room2 Homotel: Manchester Piccadilly

Design and Access Statement Addendum (Updated) – July 2024

Document Title	HMP-BA-XX-XX-TRP-A-0004 - Design and Access Statement Addendum (Updated)
Company	Bennetts Associates
Revision	P04
Date	9 th July 2024
Details	Design And Access Statement Addendum updated to address Case Officer comments issued on 13 th June 2024.
Document Number	HMP-BA-XX-XX-TRP-A-0004
Address	Bennetts Associates 38-42 Mosley Street Manchester M2 3AZ

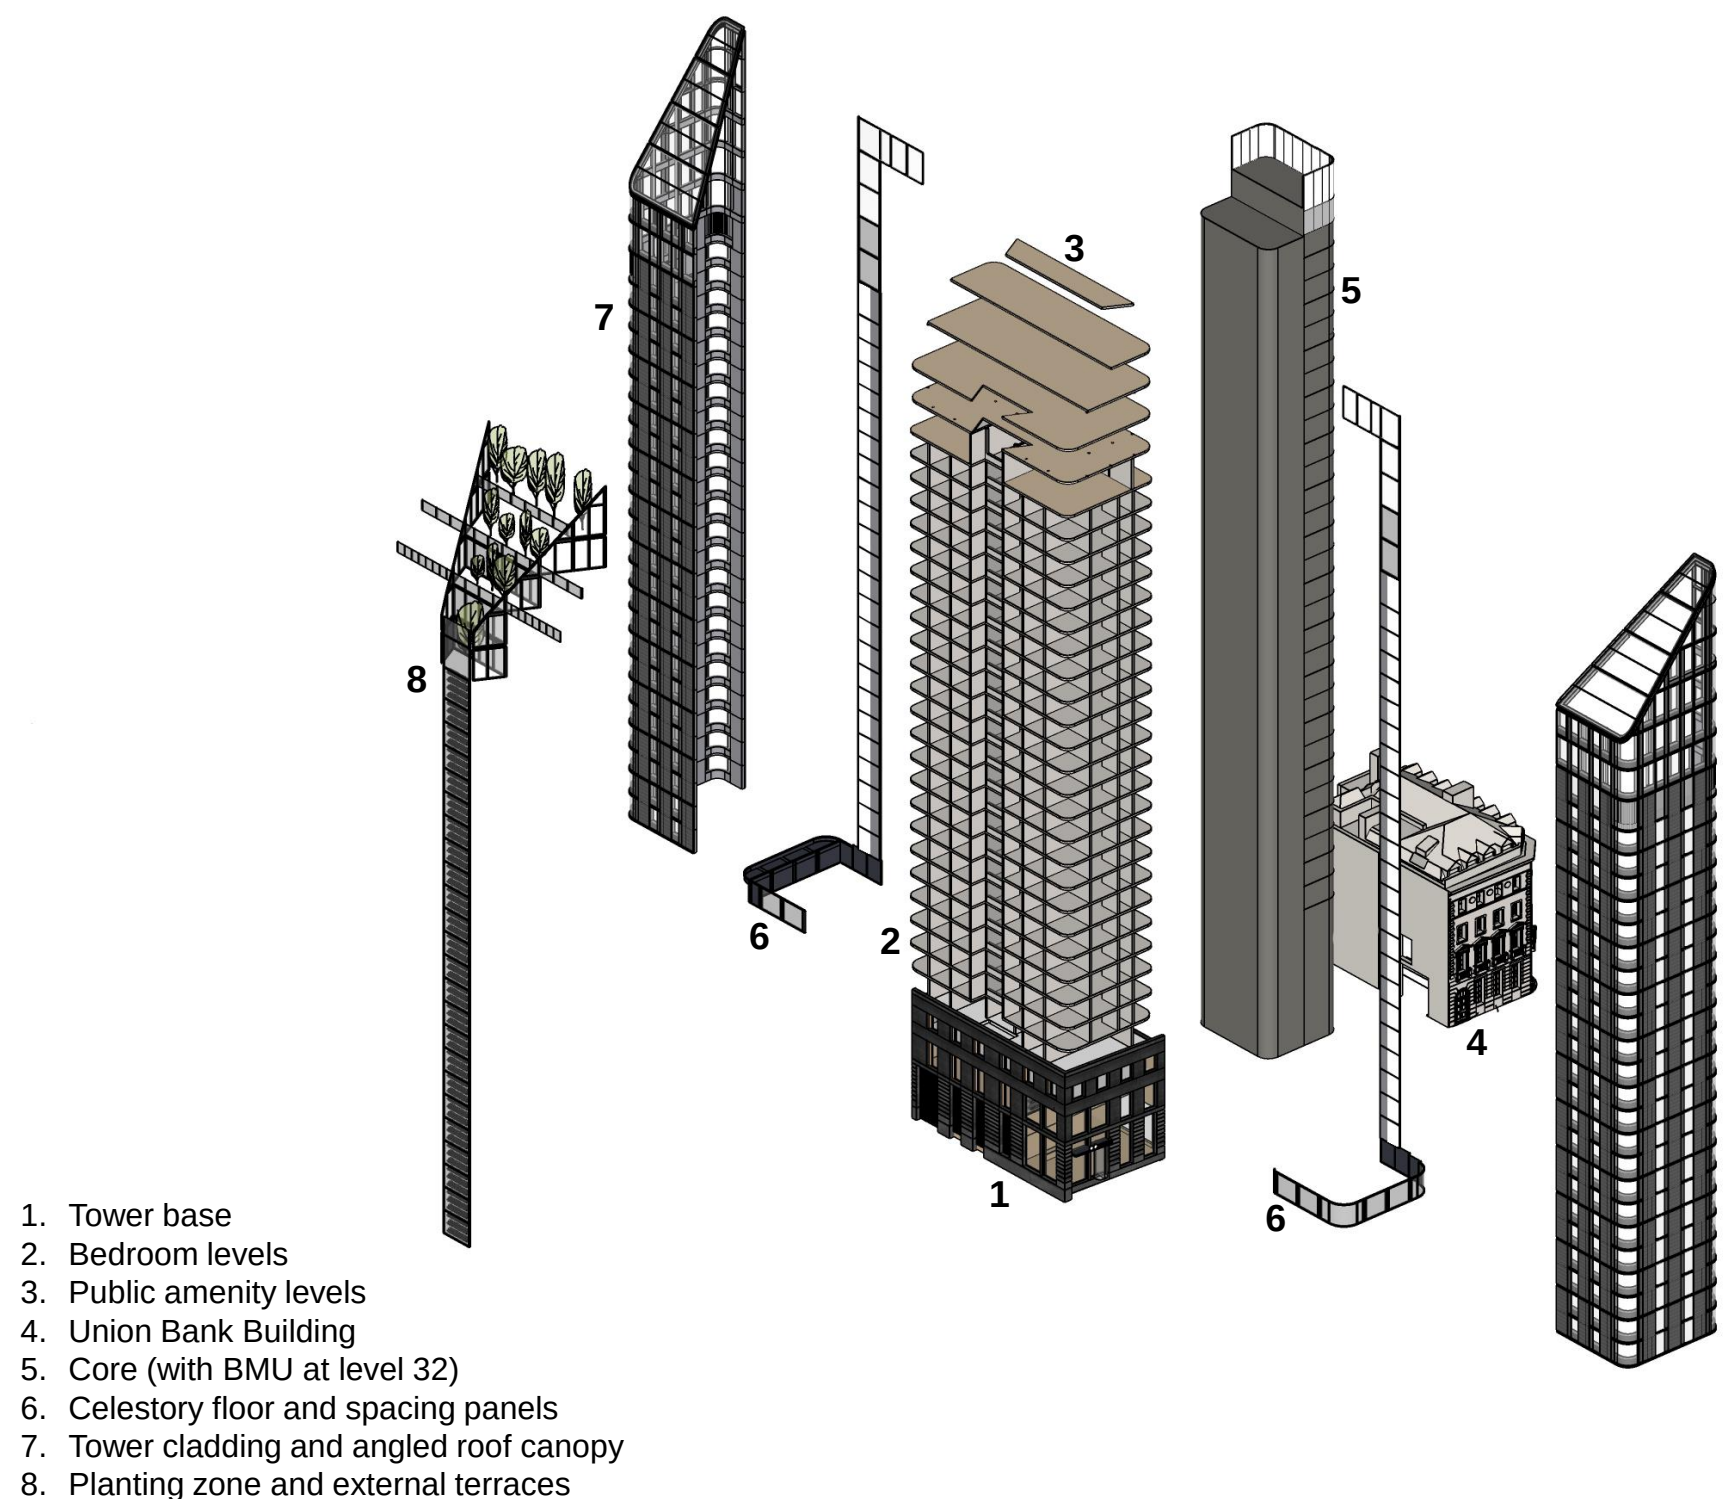
The external appearance of the stair core itself is still of concern and the large slabs of masonry add considerable mass and dominance to this element. The introduction of ribbed patterning is helpful but will not mitigate the large-scale heavy appearance of this element. Requested to revisit the design and see what can be done further to improve the heavy appearance.

We have investigated options to further reduce the mass and dominance of the service core on the north elevation. These have been informed by the established architectural concept illustrated adjacent and summarised below.
